September 15, 1995  
NG-95-2236

Subject: Duane Arnold Energy Center  
Docket No: 50-331  
Op. License No: DPR-49  
Requests for Relief from ASME Section XI Requirements:  
NDE-012 through NDE-018

DUANE ARNOLD ENERGY CENTER  
2<sup>ND</sup> 10-YEAR INTERVAL  
REQUEST FOR RELIEF NO. NDE-012

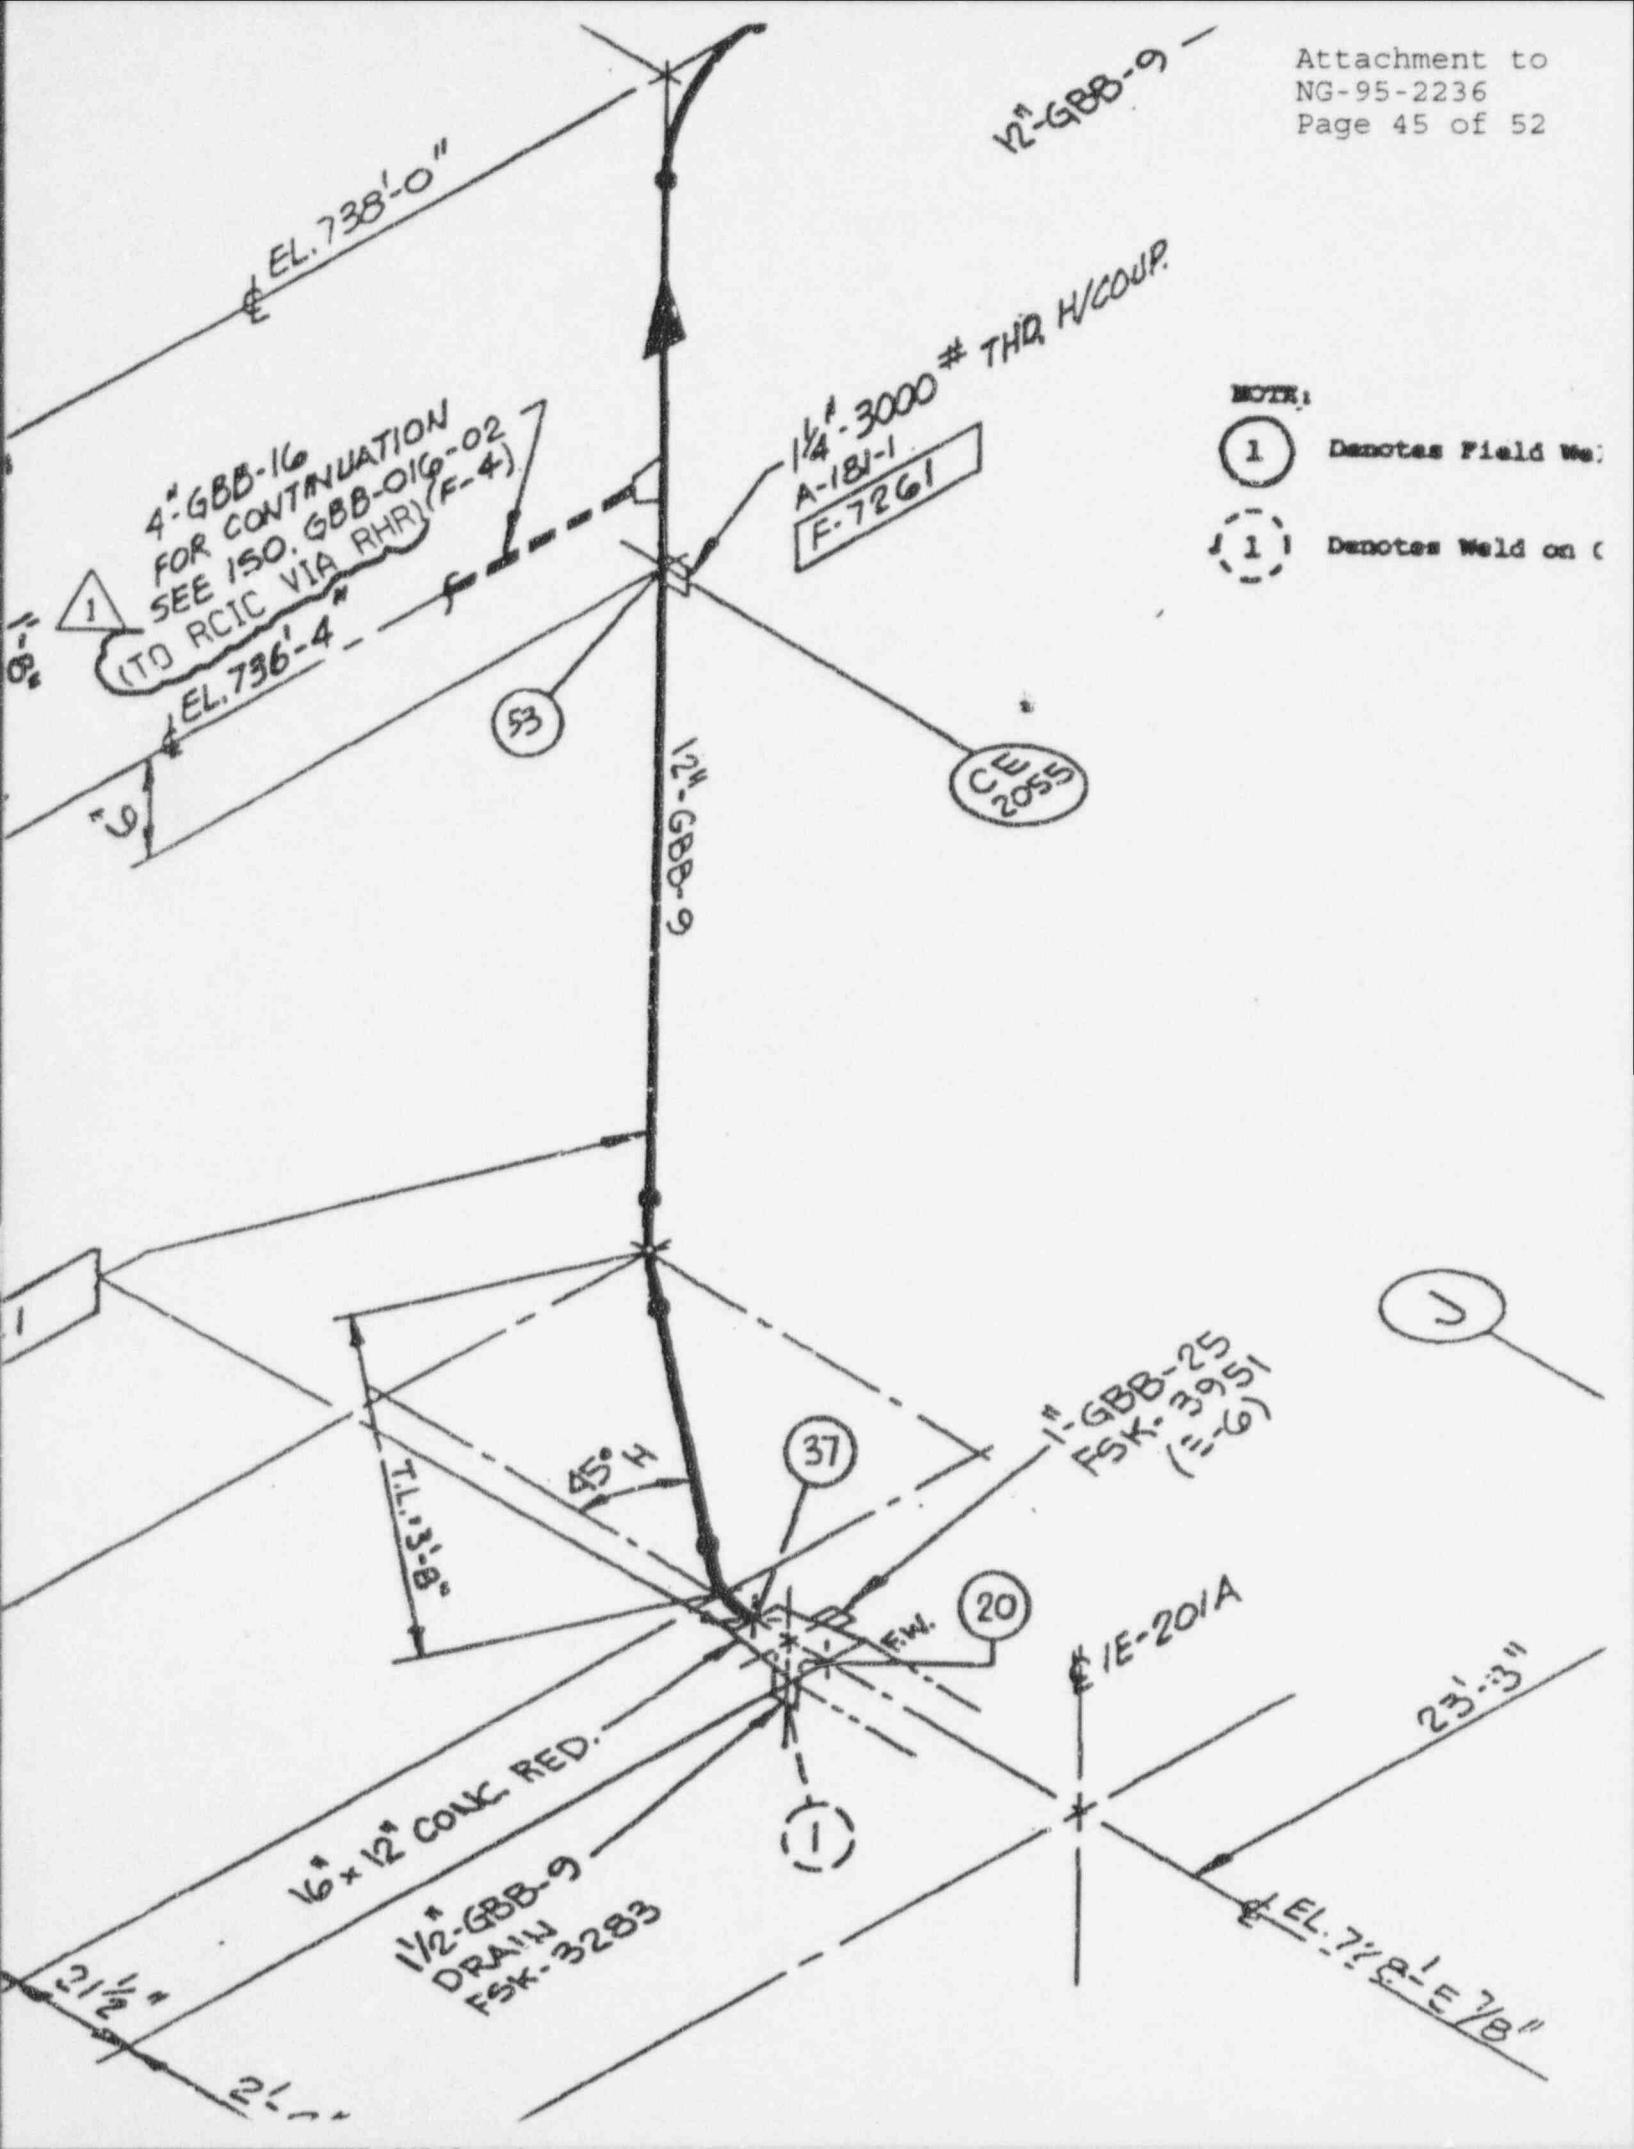
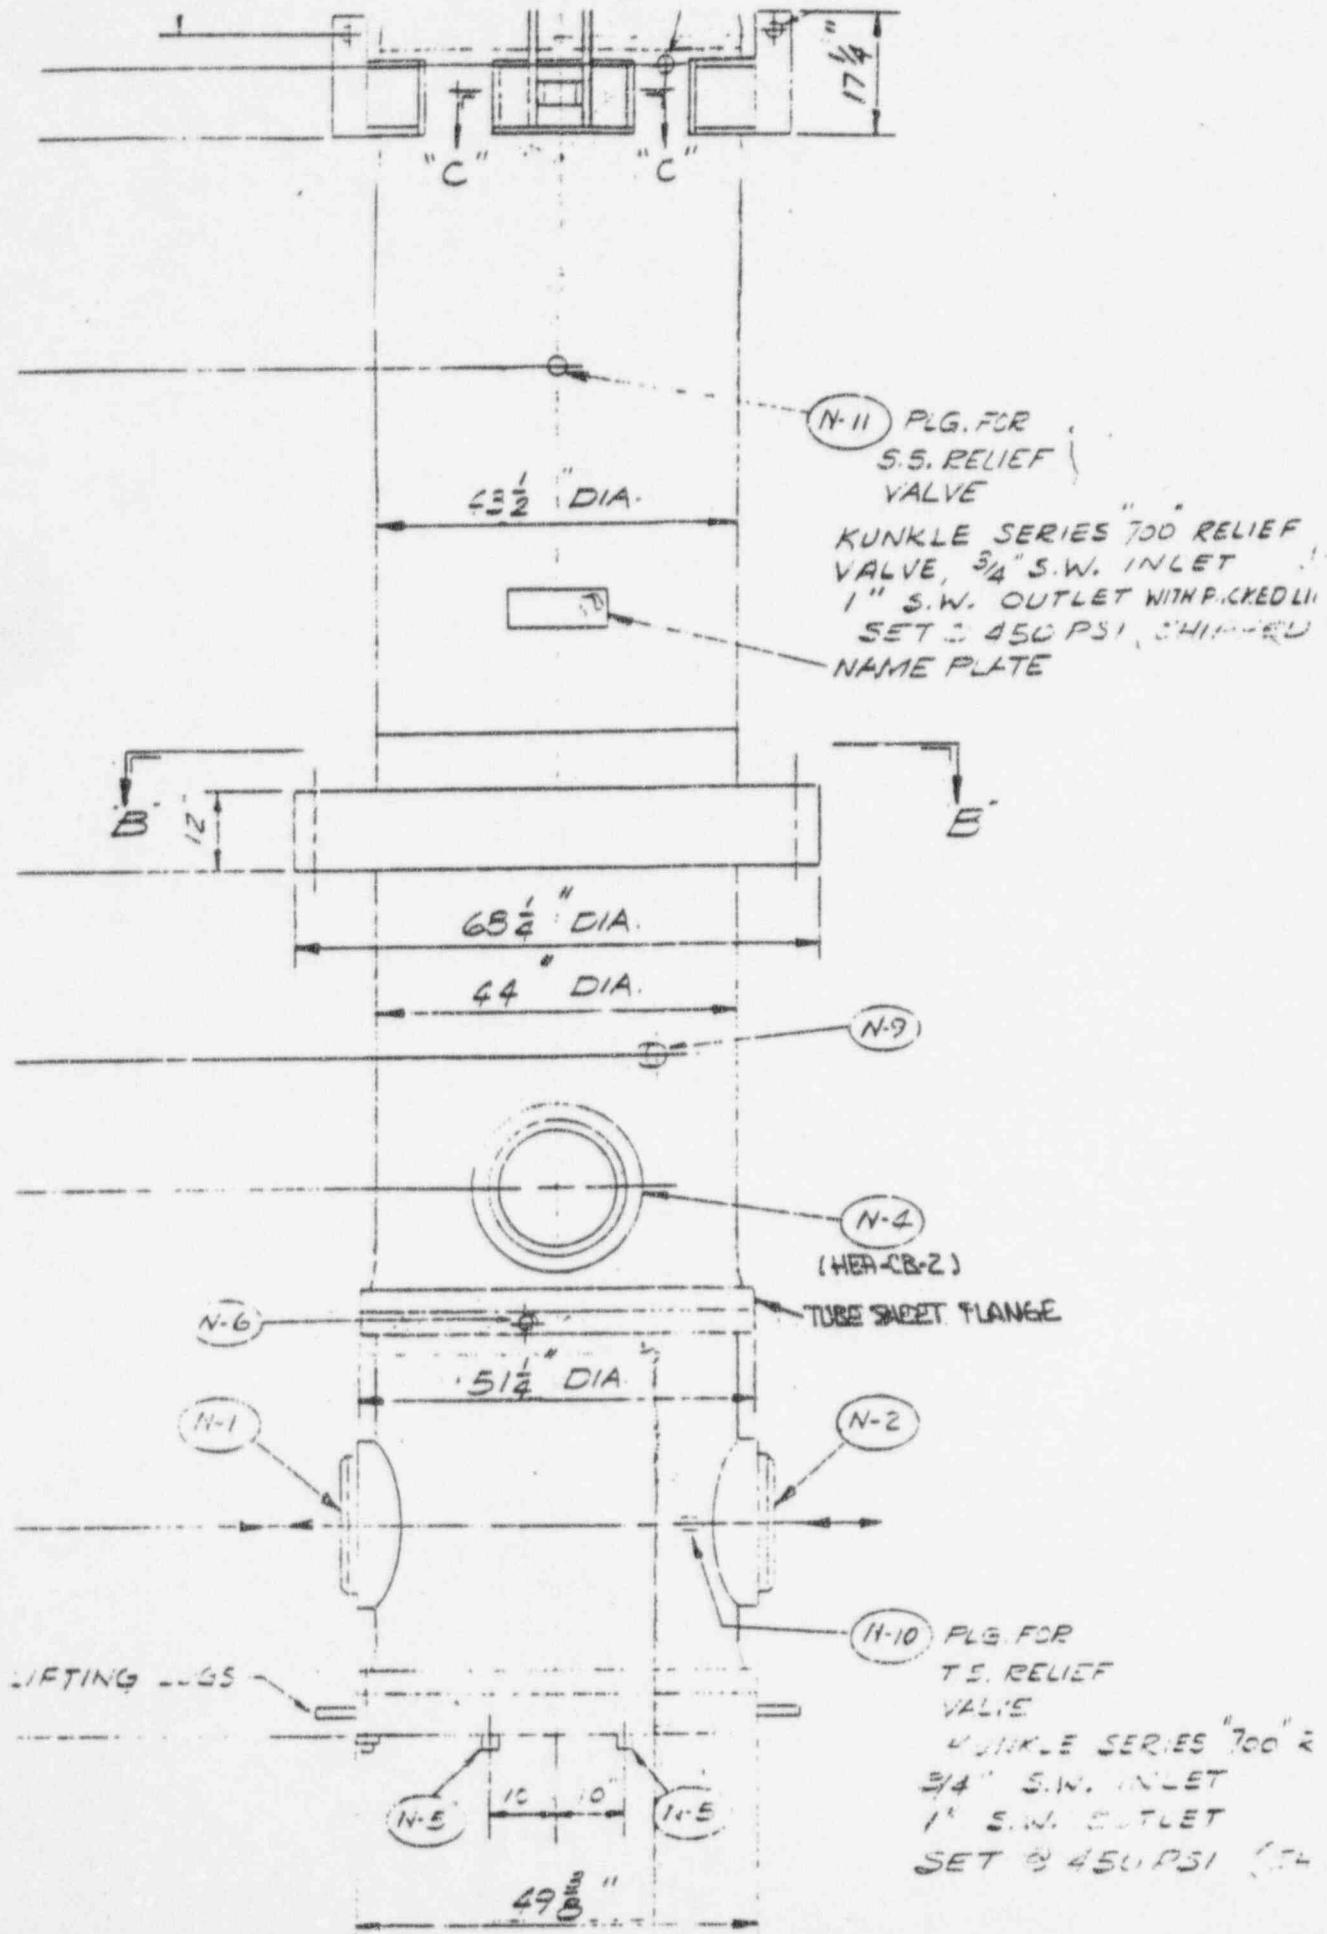
This weld is a nozzle-to-shell configuration which limits the volumetric (UT) coverage to a one-sided exam. The nozzle is located next to the tube sheet flange which further limits the volumetric examination coverage, resulting in approximately 71 % UT coverage of the weld length. Performing a radiograph of the weld requires draining the RHR System and removing the pipe or opening the tube sheet to provide access to the inside diameter. (Removal of the tube sheet is not an option because several tubes would be required to be removed along with the tube sheet.) Draining the pipe increases the dose rates in the area by a factor of 1.7 (20 mr/hr vs 12 mr/hr). This results in additional personnel exposure of 50 mr to obtain the radiograph, including the installation and removal of insulation and shielding. In addition, removing the pipe from the nozzle would require the pipe to be cut in two places and then rewelded which would take about 102 hours. Additional examinations would then be needed for the welds that reattach the pipe to the system. The total dose for the project would be approximately 2 R. The additional 29 % coverage would provide only a small potential for increasing plant safety while greatly increasing expenditures of plant manpower and radiation exposure.

IES Utilities Inc. proposes to perform volumetric examination of the 71% weld length. The alternative examination coverage allowed by Code Case N-460 will also be used.
